February 6, 1984

Docket No. 50-423  
B11026

Millstone Nuclear Power Station, Unit No. 3  
Probabilistic Safety Study (PSS)

6-INCH COLD LEG BREAK PLOTS

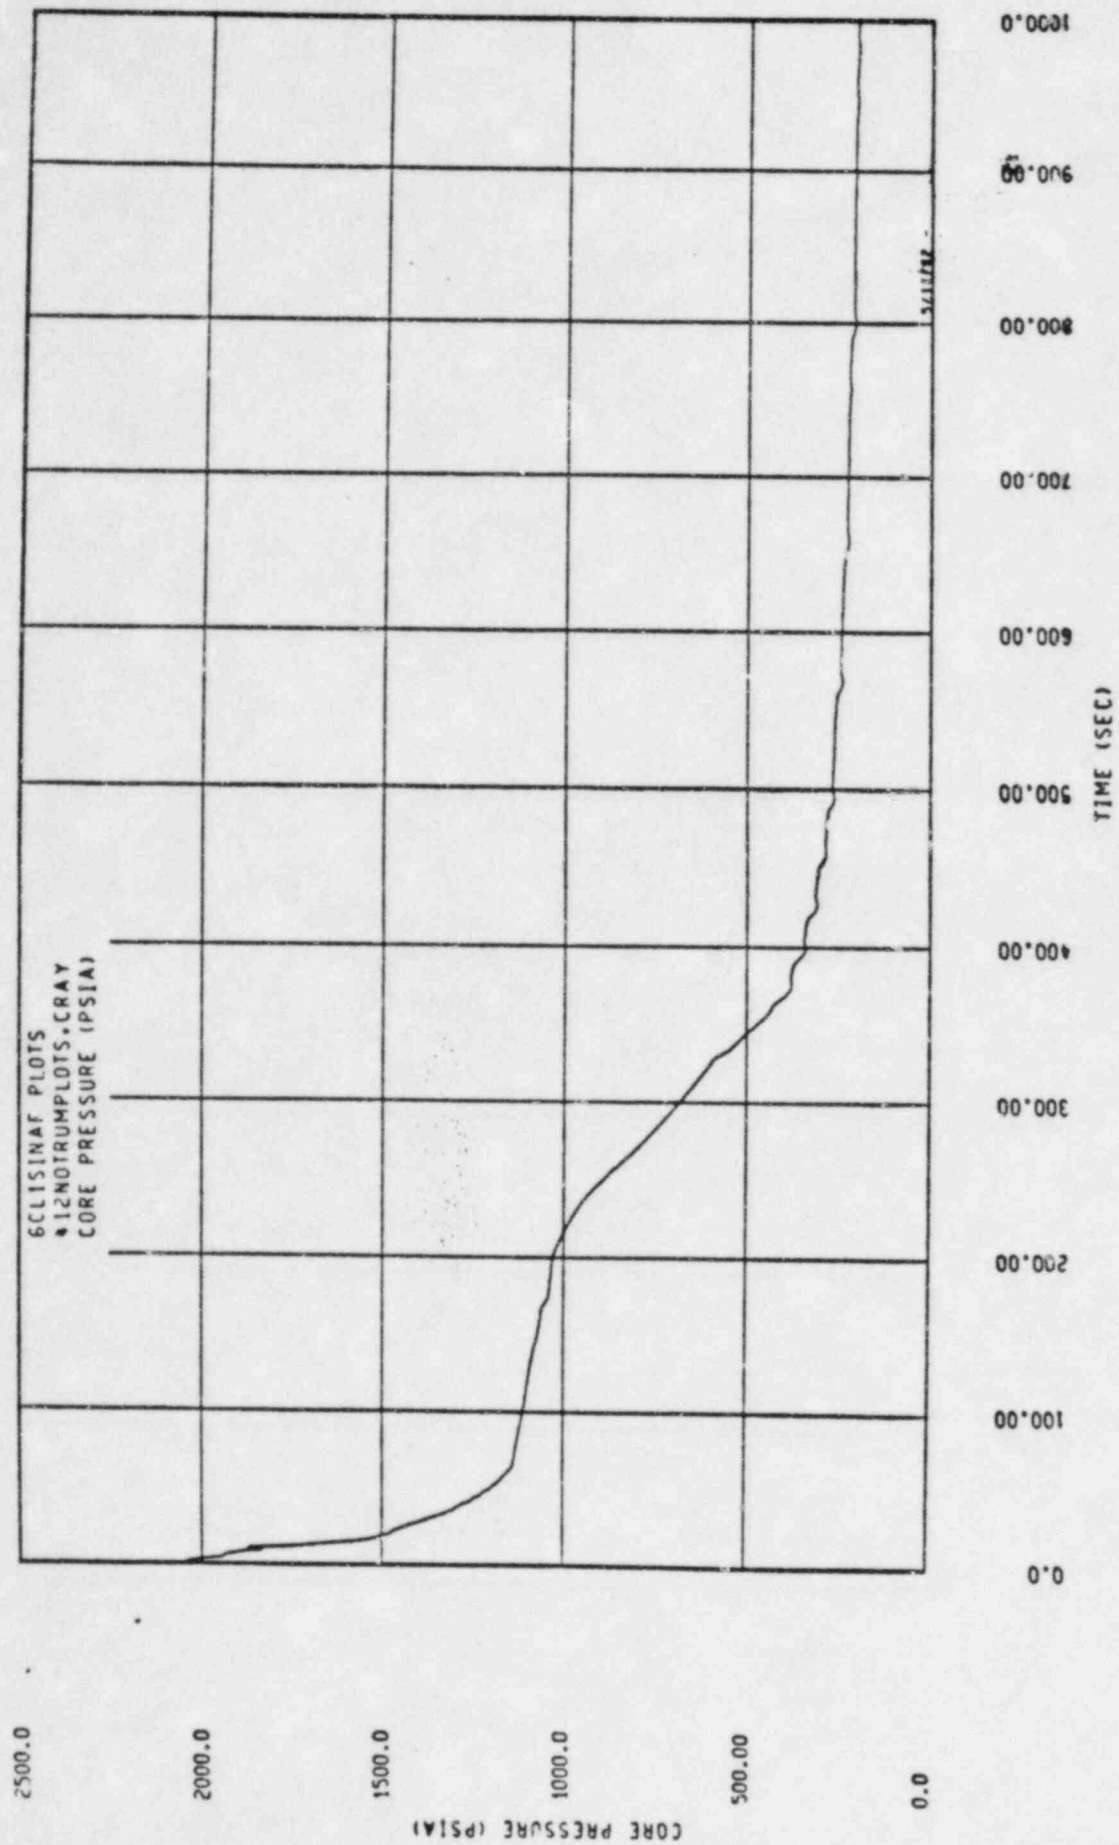
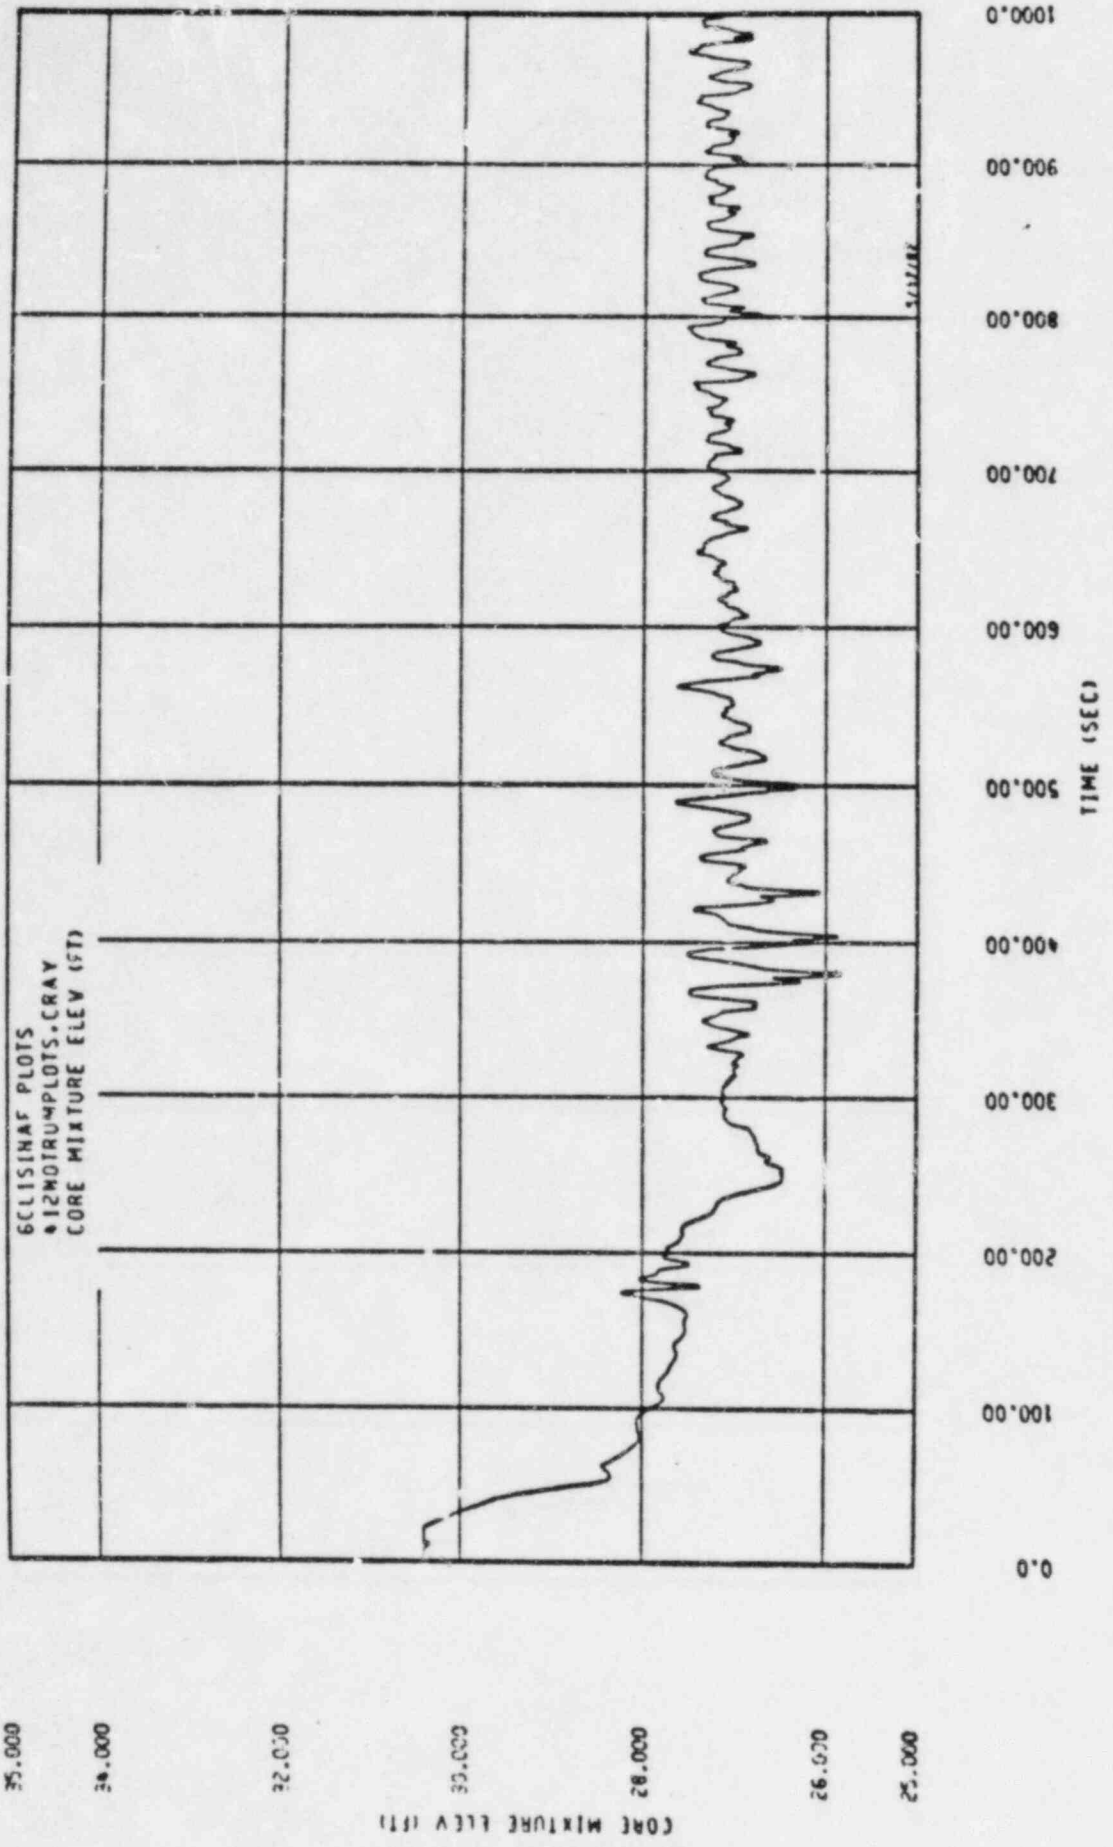
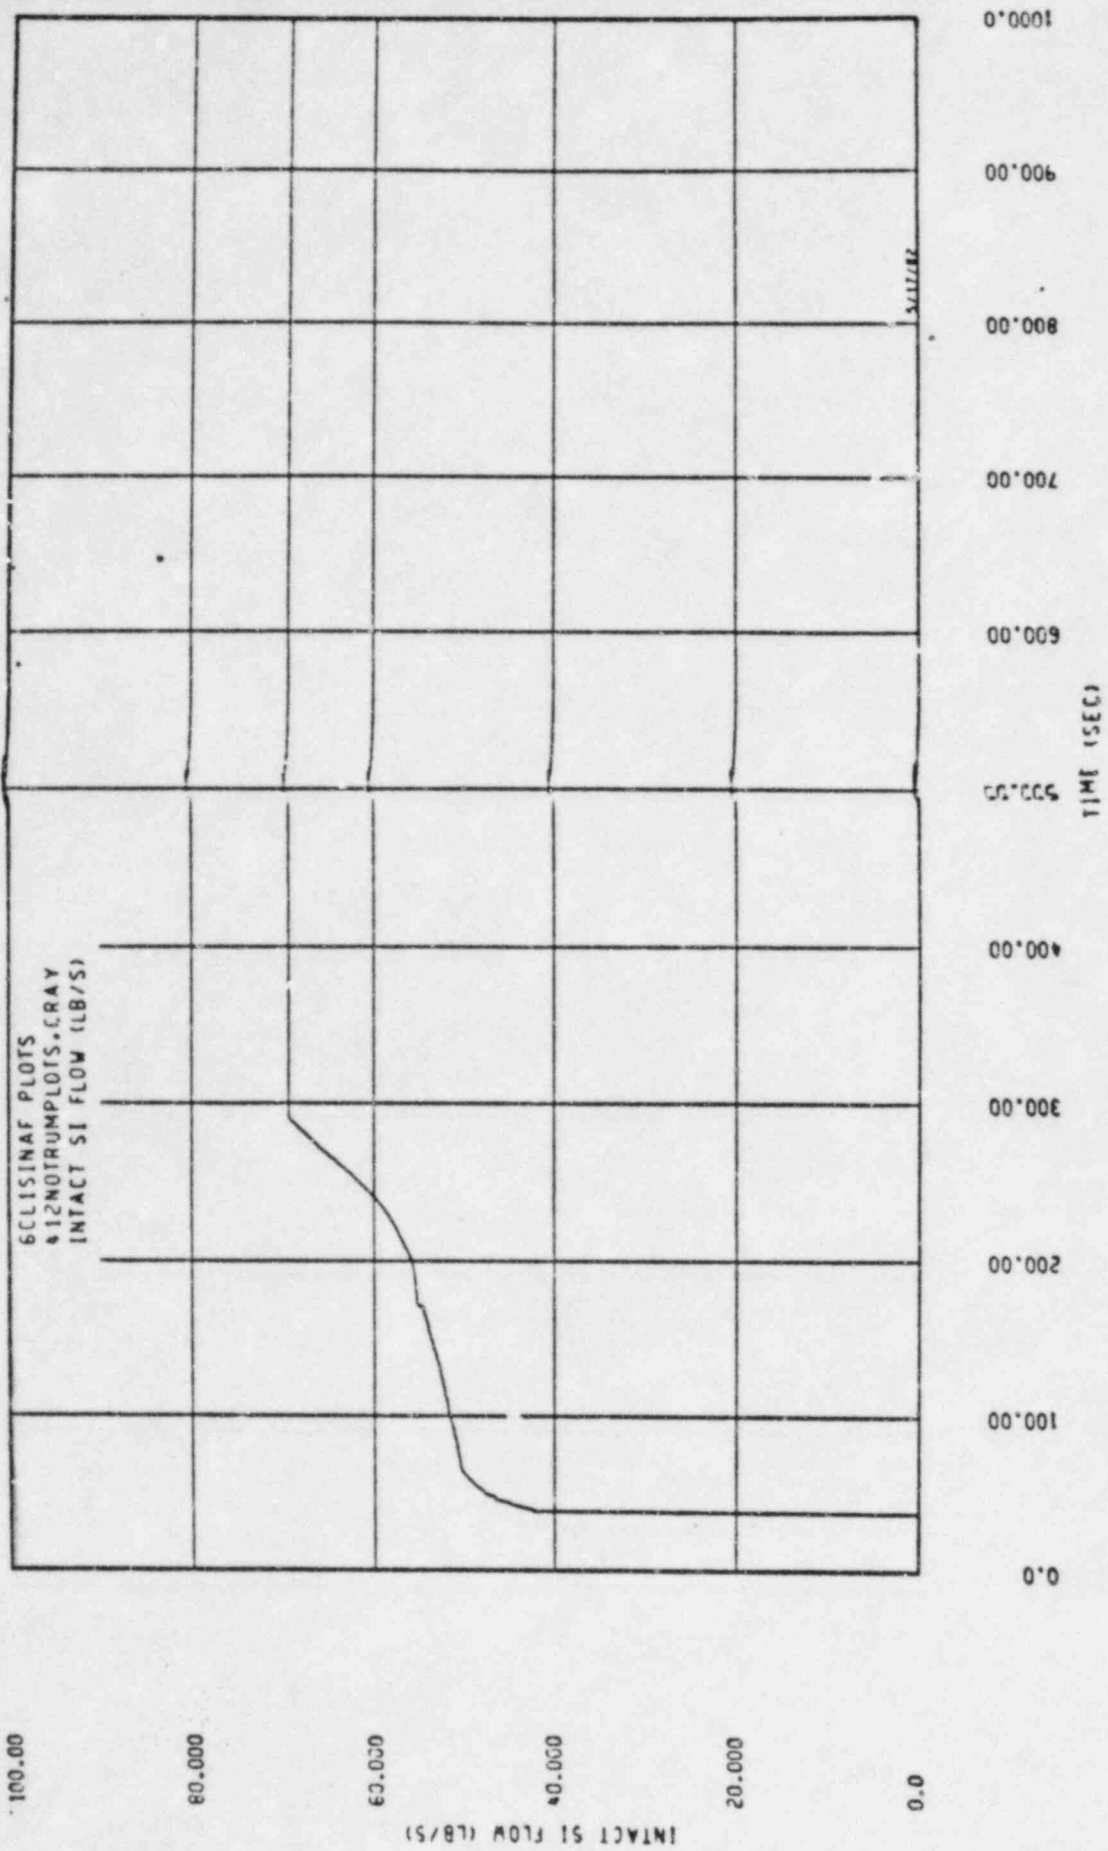
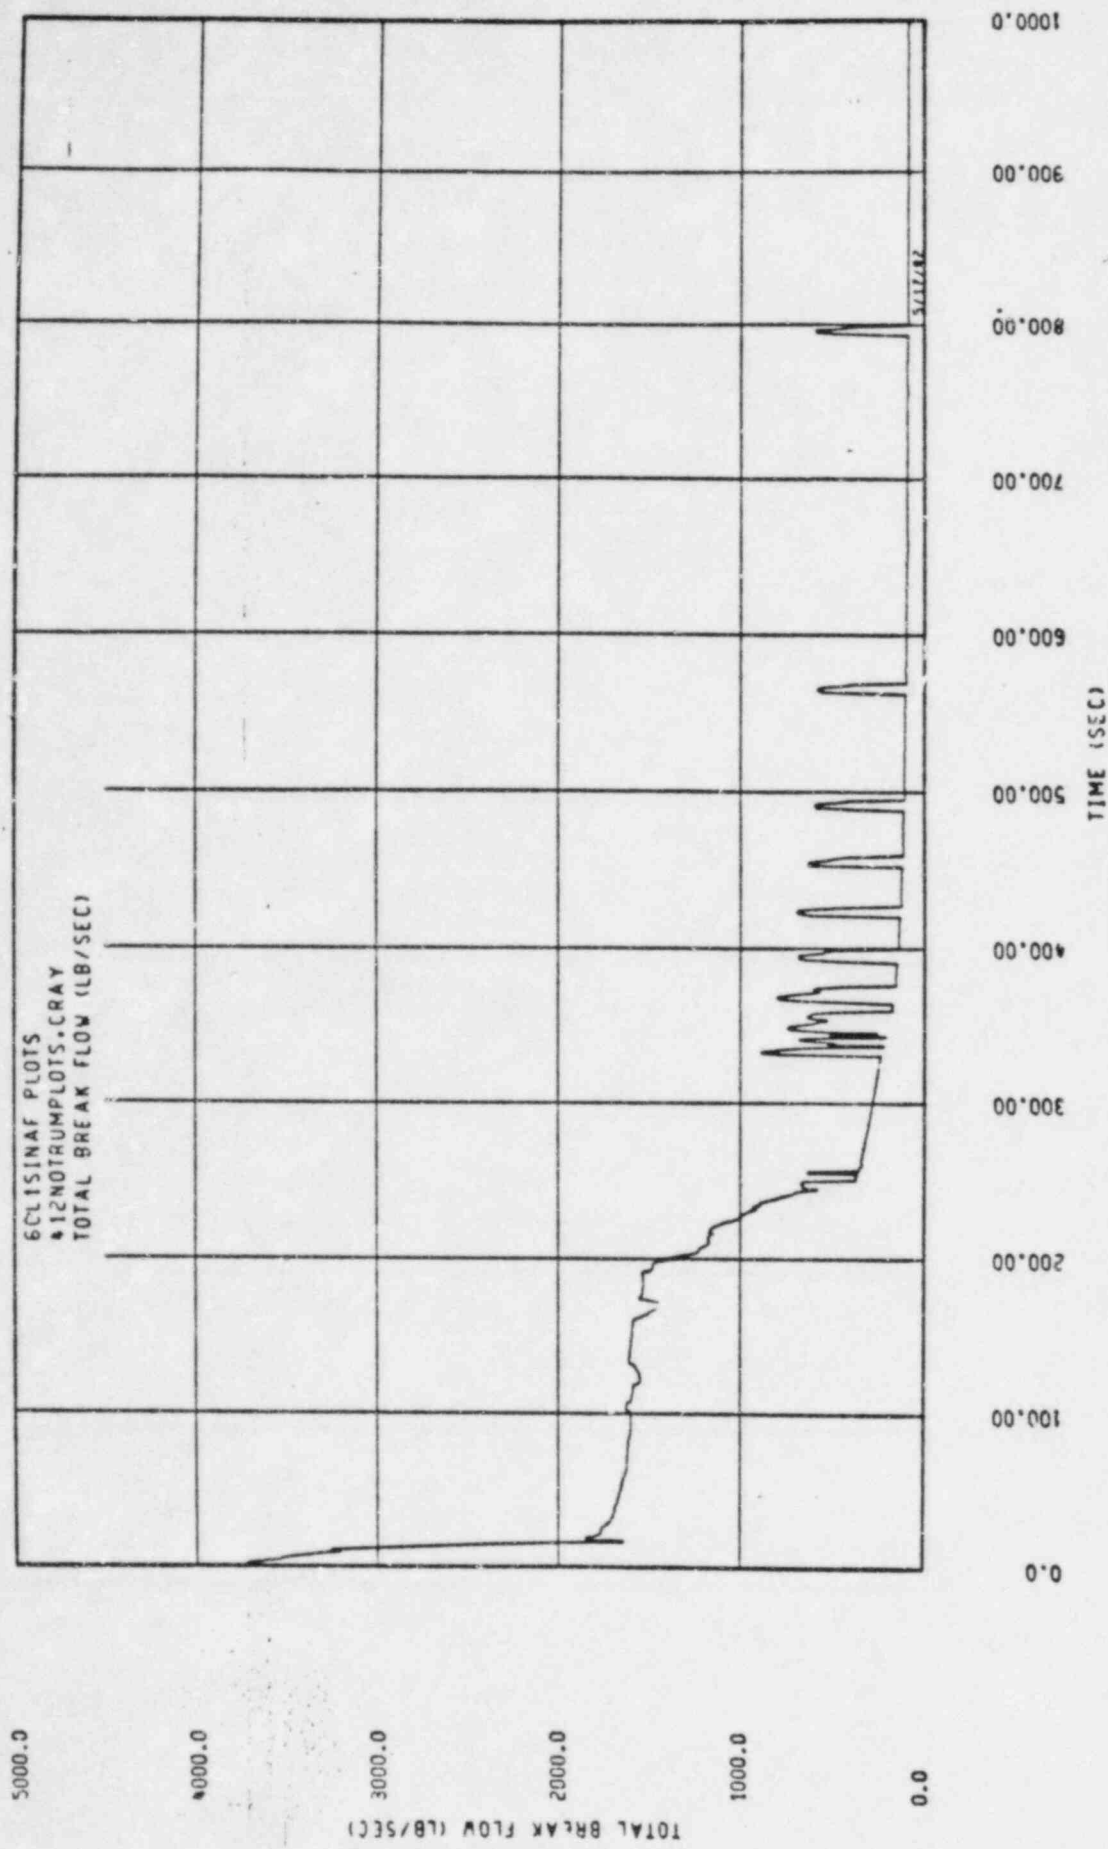
Question 720.3: Provide a summary of Westinghouse Calc Note CN-PRA-83-022 which identifies computer codes used, key assumptions and transient plots used in the analysis.

Case B calculations were carried out to 1000 seconds which was adequate to show the establishment of a long-term stable condition. This calculation shows that the minimum safety injection flow and accumulator flow is sufficient to maintain vessel mixture level above the core and prevent core melt.

These two analyses show that while the flow minimum safety injection flow cannot maintain the RCS inventory above the break location, the flow is sufficient to maintain the vessel mixture level core the core. These conclusions were consistent with conclusions reached for similar LOCA analyses.<sup>(1)</sup> A detailed description of small break LOCA phenomena can be found in WCAP 9600. The transient time plots for key plant parameters for both cases are provided herein.

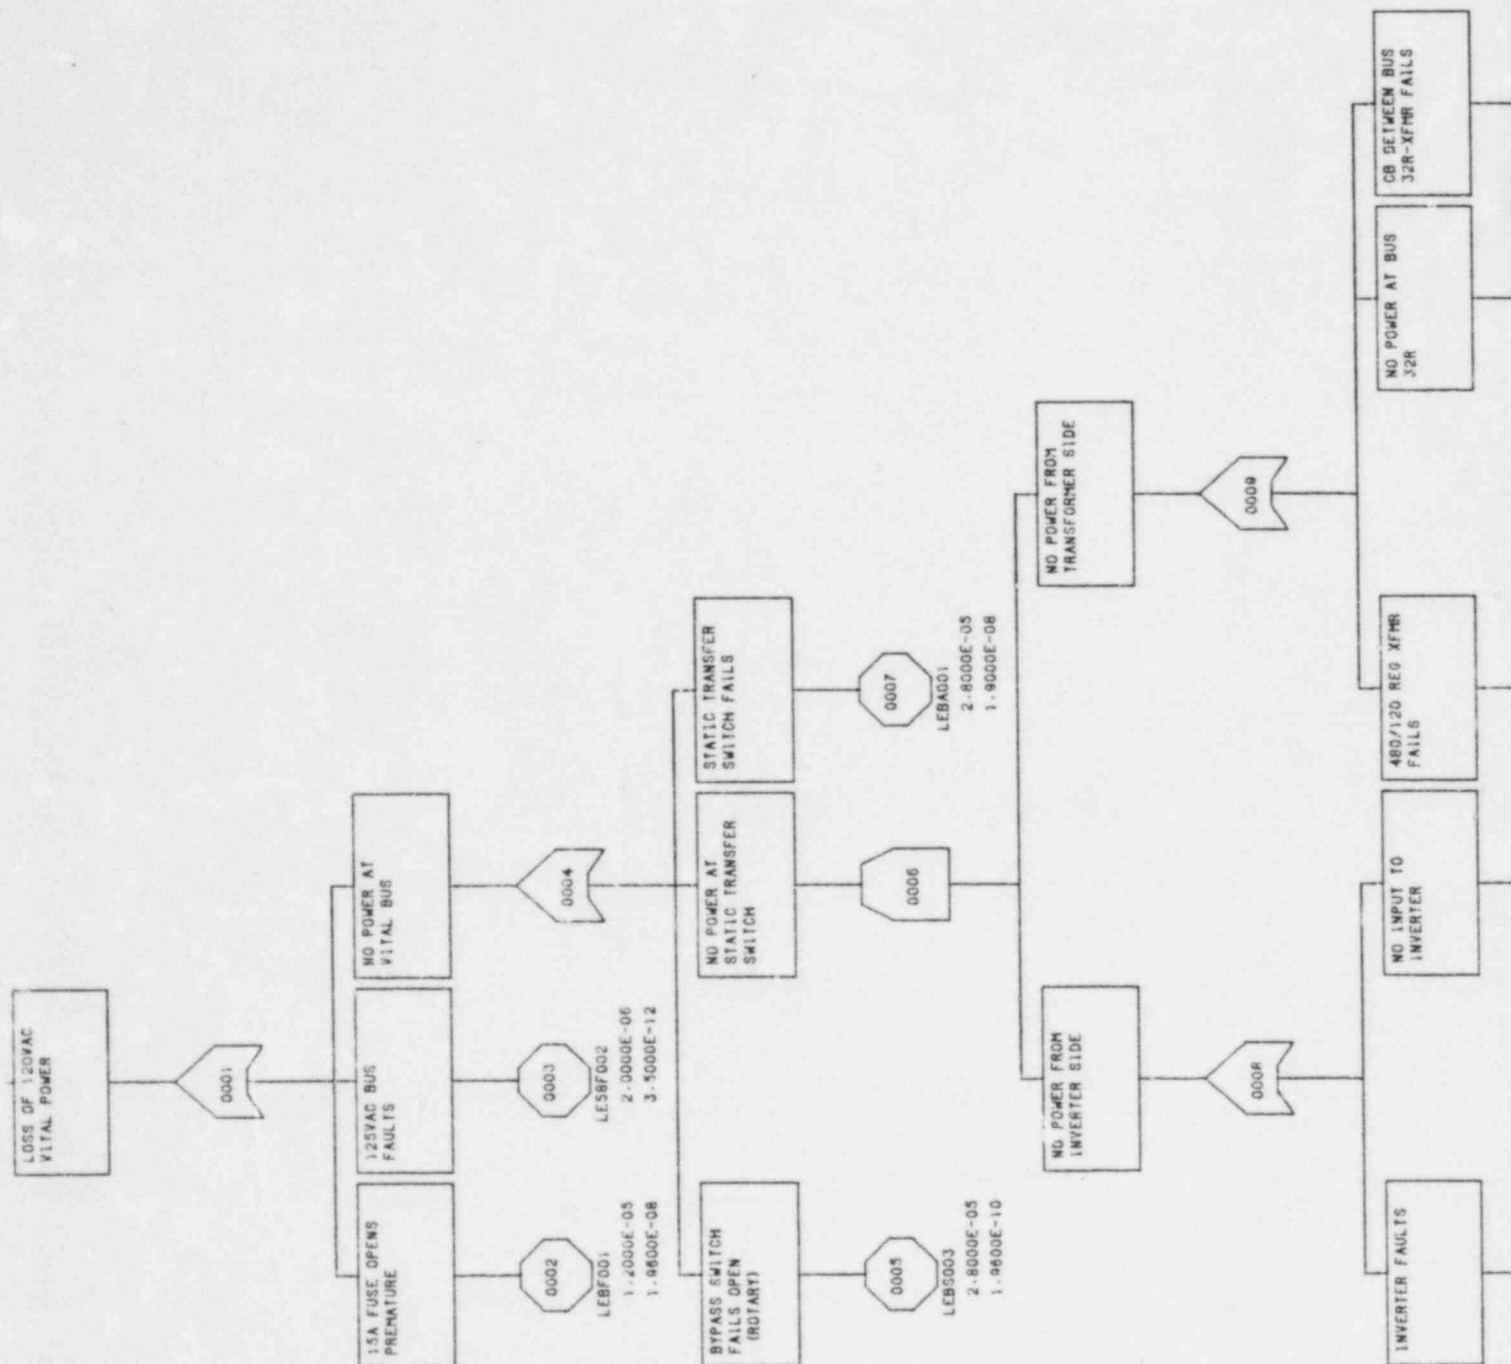
Question 720.29: In the fault tree for the vital 120 AC bus, the loss of power on bus 34C is modeled as a separate event (different labels, different unavailability) on two inputs to an AND gate. Why?

Response: The fault tree for the 120V Vital AC Bus System, shown as Figure 2.3.3.2-2, is an early version of the tree and was inadvertently used in the PSS (there were several revisions made to the vital AC tree). As noted in the response to Question 720.71, the vital AC power system was only quantified for those cases where AC power was available. A later, more correct version of the tree and WAM CUT quantification results are attached. There is no significant difference between the attached results and those used in the PSS.
